Project	<b>IEEE 802.16 Broadband Wireless Access Working Group &lt;<a href="http://ieee802.org/16">http://ieee802.org/16</a>&gt;</b>	
Title	<b>Fragmented Transmission of the MOB-NBR-ADV Message</b>	
Date Submitted	<b>2004-08-31</b>	
Source(s)	Geunhwi Lim, Yong Chang, Hong Sung Chang, JungWon Kim, TaeWon Kim Samsung Electronics Co. Ltd.	<a href="mailto:geunhwi.lim@samsung.com">geunhwi.lim@samsung.com</a>
	Yigal Eliaspur Intel Cooperation	<a href="mailto:Yigal.eliaspur@intel.com">Yigal.eliaspur@intel.com</a>
	Yigal Leiba Runcom Ltd	<a href="mailto:Yigall@runcom.co.il">Yigall@runcom.co.il</a>
Re:		
Abstract	<b>Propose a mechanism to transmit fragmented MOB-NBR-ADV Message</b>	
Purpose	Adoption of proposed changes into P802.16e /D4-2004	
Notice	This document has been prepared to assist IEEE 802.16. It is offered as a basis for discussion and is not binding on the contributing individual(s) or organization(s). The material in this document is subject to change in form and content after further study. The contributor(s) reserve(s) the right to add, amend or withdraw material contained herein.

Figure 1 Size of MOB-NBR-ADV Message

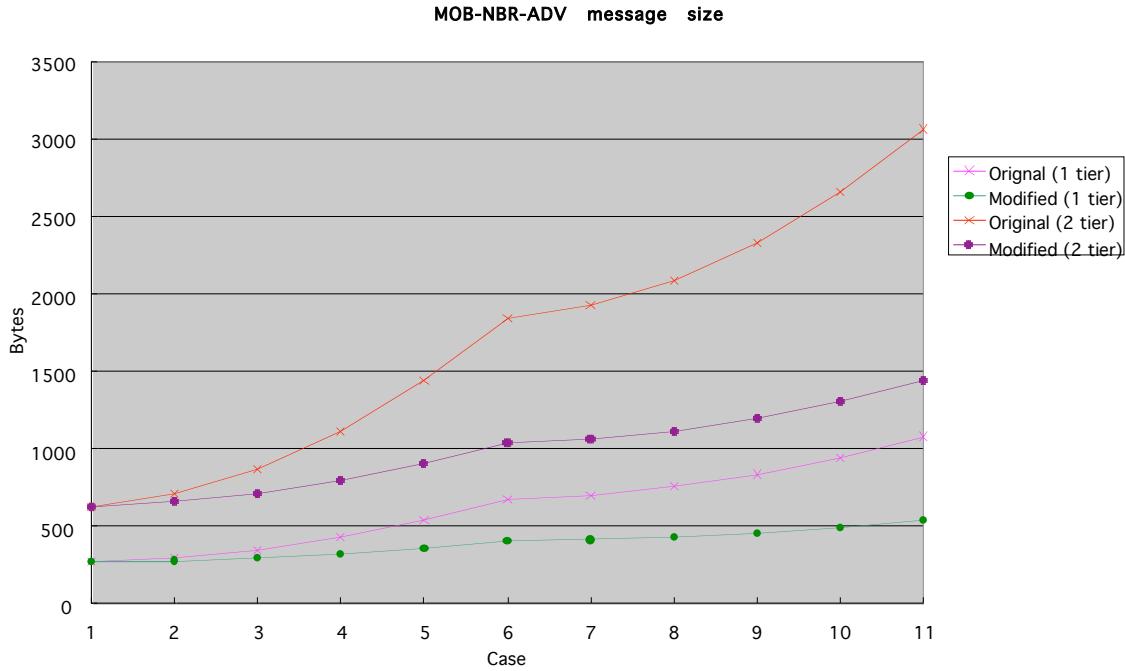
Figure 1 shows the size of MOB-NBR-ADV message depending on the deployment of neighbor cells. Table 1 is the definition of the simulation case. We assume that 6 neighbors exist in 1 tier, 18 neighbors exist in 2 tier. The table shows the distribution of the DCD/UCD message difference. Hence, the DCD/UCD messages of the all neighbors are same in the case 1 and all different in the case 11.

As shown in the Figure 1, the maximum size of the MOB-NBR-ADV message is over 3000 bytes and the minimum size is 600 bytes considering neighbors in two tier.

Figure 2 Fragmentation of NBR\_ADV Message

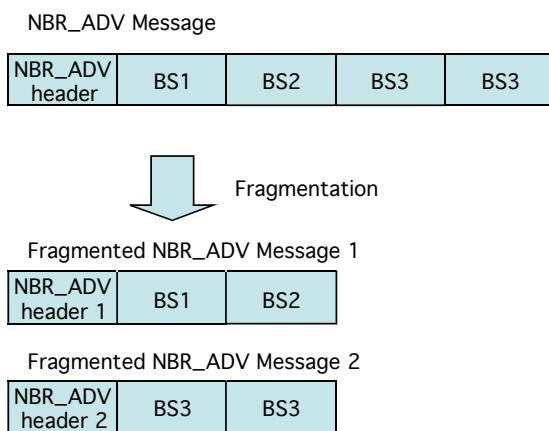
Here, we propose a fragmentation mechanism for MOB-NBR-ADV message. By adding Fragmentation Index and Total Fragmentation fields in the MOB-NBR-ADV message we can divide the TLV portion of the message and transmit them over several messages. Hence, the individual message size will be decreases to be sent in a frame. A MSS should receive all the fragments to get the complete information about the neighbors.
